REGULATORY INFORMATION DISTRIBUTION SYSTEM (RIDS)

SUBJECT: Application for amends to Licenses NPF-41,NPF-51 & NPF-74, *See Proposed Changes to T.S. I*
 changing Tech Spec 3/4.7.11, "Shutdown Cooling Sys" to D
 delete auto-closure interlock surveillance of surveillance S
 requirement 4.7.11b,per Generic Ltr 88-17.

Subject: Palo Verde Nuclear Generating Station (PVNGS)
Units 1, 2, & 3
Proposed Technical Specification Amendments to Specification 3/4.7.11, Shutdown Cooling System, to Delete the Auto-closure Interlock Surveillance of Surveillance Requirement 4.7.11b.
File: 91-004-419.05; 91-056-026

Palo Verde Units 1, 2 & 3
Figure 1

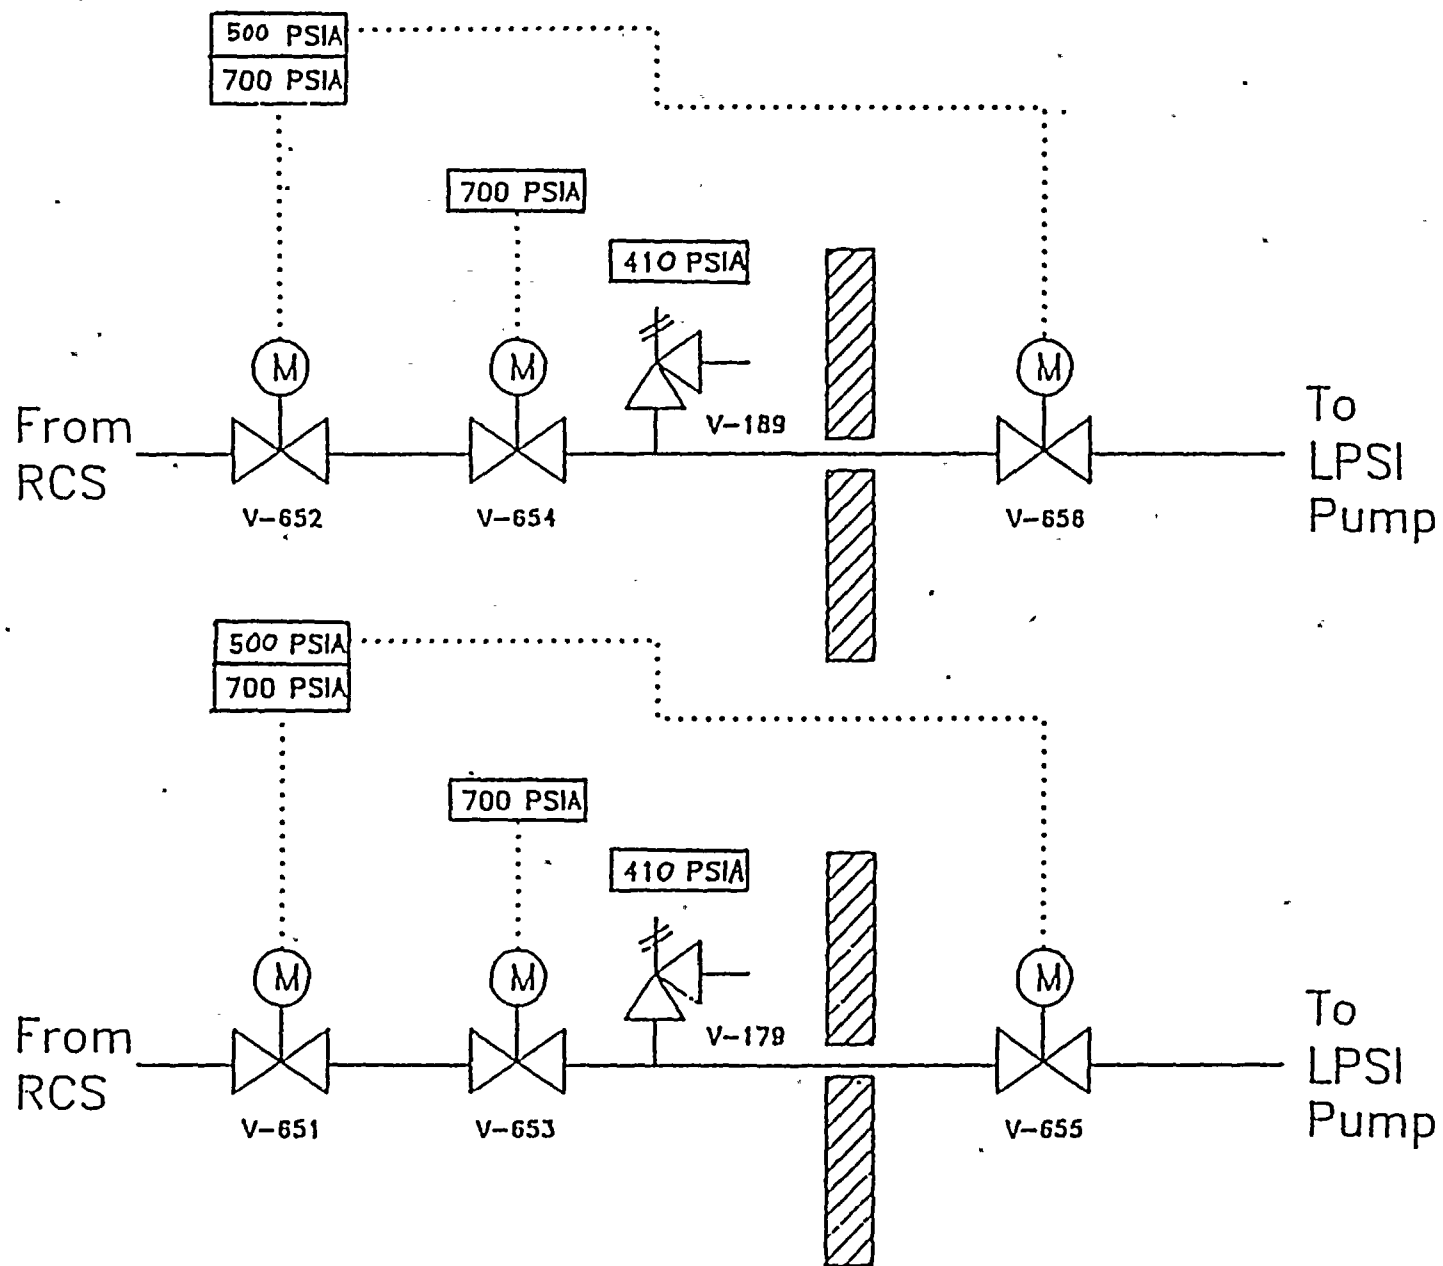
provided, each capable of maintaining the RCS pressure boundary with the other device failed. General Design Criteria 55 also requires that, when these lines penetrate the reactor containment, there must be at least one isolation device on each side of the containment boundary. Figure 1 on page 11 shows the SDCS suction line arrangement for PVNGS.
